SUBJECT: Amendment 7 to the McClellan Development Authority (MDA) Explosives Safety Submission (ESS) for the Munitions and Explosives of Concern (MEC) Removal Action at Fort McClellan, AL

# **Amendment 07**

**MEC Remediation at McClellan**  
**MRS - 6**  
**Anniston, Alabama**

Figure 2-1	MRS-6 Exclusion Zone.....	3
------------	---------------------------	---

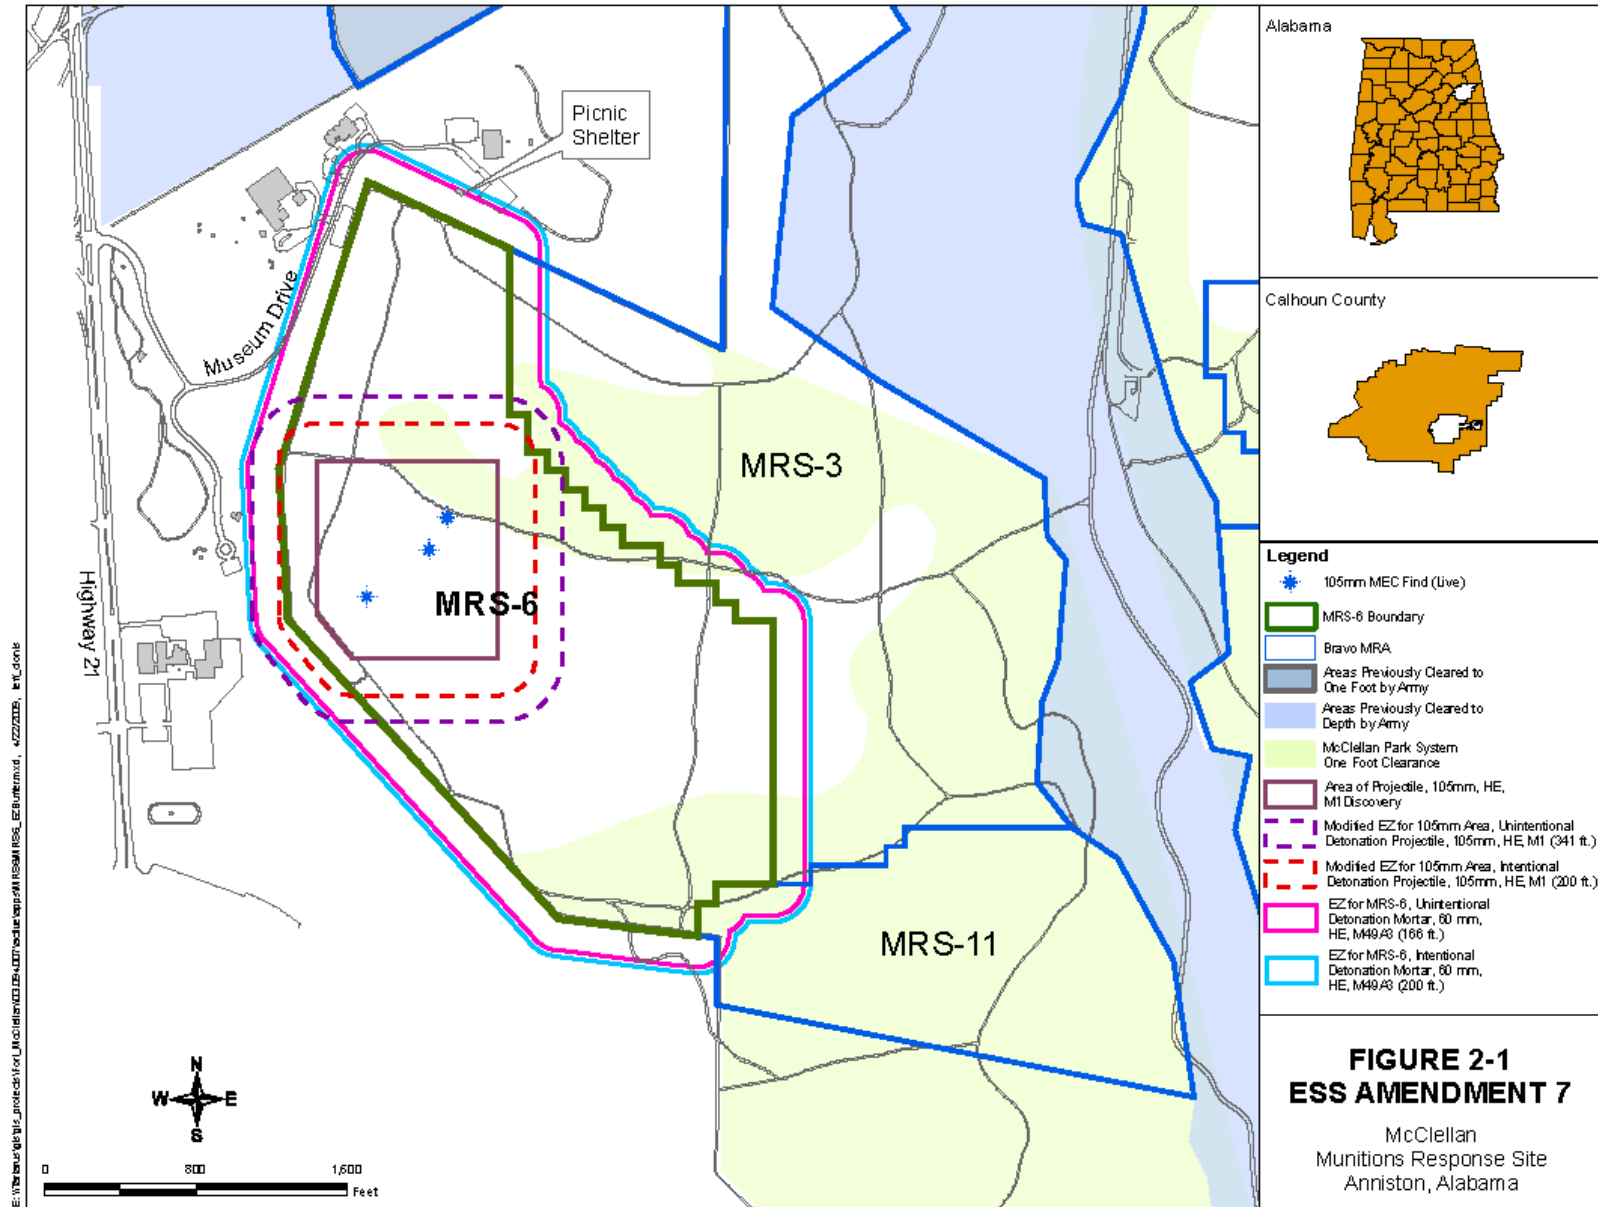
The Fragmentation Data Review Form for the M1, 105mm HE Projectile is provided in Table 2-1. The MGFDF and corresponding EZ distance for the area containing 105mm HE Projectiles in MRS-6 is shown in Figure 2-1. The EZ and MSD for an unintentional detonation during intrusive operations in the area of the 105mm discoveries is 341 feet and represents the Quantity-Distance (Q-D) Arc based on the HFD of the M1, 105mm HE Projectile. In the remainder of MRS-6, the EZ and MSD for an unintentional detonation is 166 feet based on the M49A3, 60mm HE Mortar as approved in Amendment 05 to the ESS (USATCES approval memo dated 24 July 2008).

The maximum fragment range for the M1, 105mm HE Projectile is 1939 feet and is the EZ and MSD for intentional detonations. For any intentional detonation where any portion of the 1939 foot arc would extend offsite engineering controls will be used to reduce the EZ and MSD and to mitigate the potential fragmentation and blast hazards. The EZ and MSD for an intentional detonation with engineering controls is 200 feet. Engineering controls for intentional detonations will be used as described in the *Use of Sand Bags for Mitigation of Fragmentation and Blast Effects due to Intentional Detonation of Munitions*, HNC-ED-CS-S-98-7 dated August 1998 or in the *Use of Water for Mitigation of Fragmentation and Blast Effects Due to Intentional Detonation*

*of Munitions*, HNC- ED-CS-S-00-3, dated September 2000. The maximum extent of the MRS-6 EZ extends off of McClellan to the west and north on to City of Anniston property as indicated on Figure 2-1. There is a picnic shelter present within the EZ which is part of a community center managed by the City of Anniston Parks & Recreation department which is used periodically. Also, a portion of Museum Drive and parking lots are located in the EZ and it is also noted on Figure 2-1. Closure of Museum Drive, parking lots and the picnic shelter will be coordinated with the Parks & Recreation department and all potentially affected areas will be evacuated and guarded during intentional detonations to ensure that the EZ will be effectively secured during MEC operations in MRS-6.
